Technical Bulletin T763

Product: A/V Receiver

Hardware Technical Bulletin: T763-H2004-03

Subject: HDTV Component
Video change

Figure1

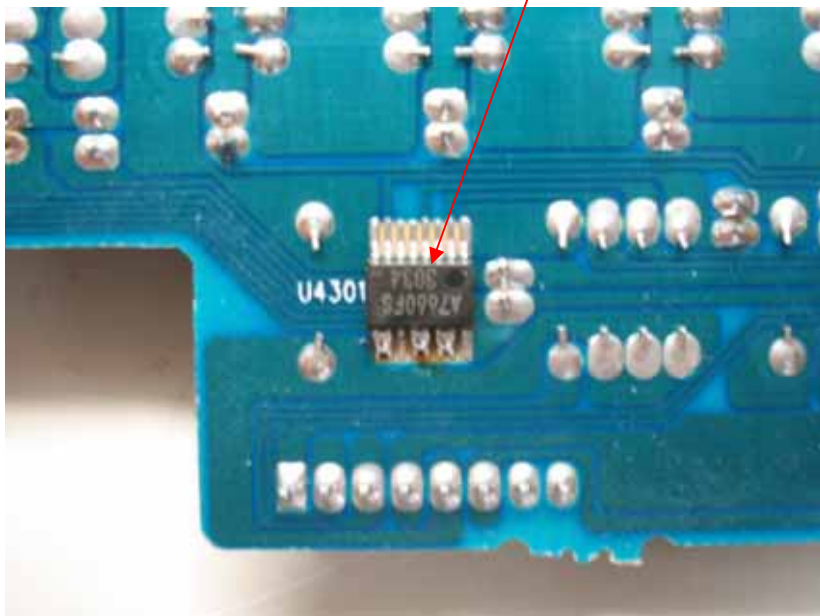
On the component video PCB U4301

- A) Link the following pins on U4301;
- Pins 9 to 10
 - Pins 12 to 13
 - Pins 14 to 15

Figure 2

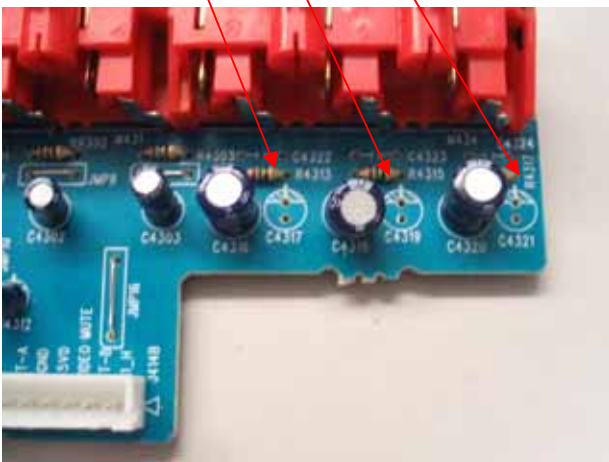
B) Remove C4317, C4319, C4321.

Figure 3

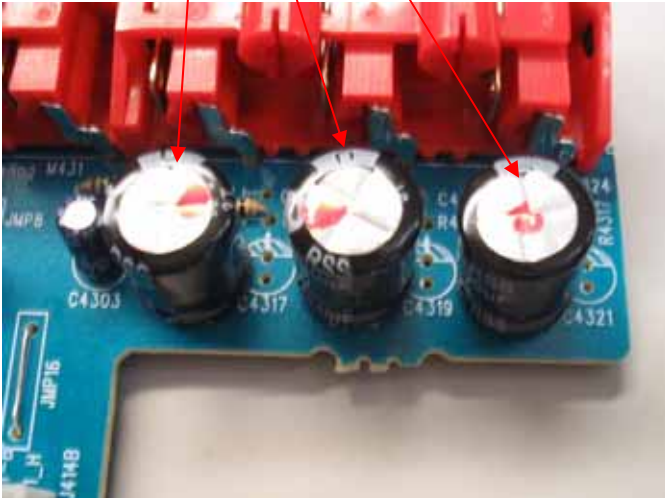
C) Replace C4316, C4318, and C4320 with 1000 uF 6V.
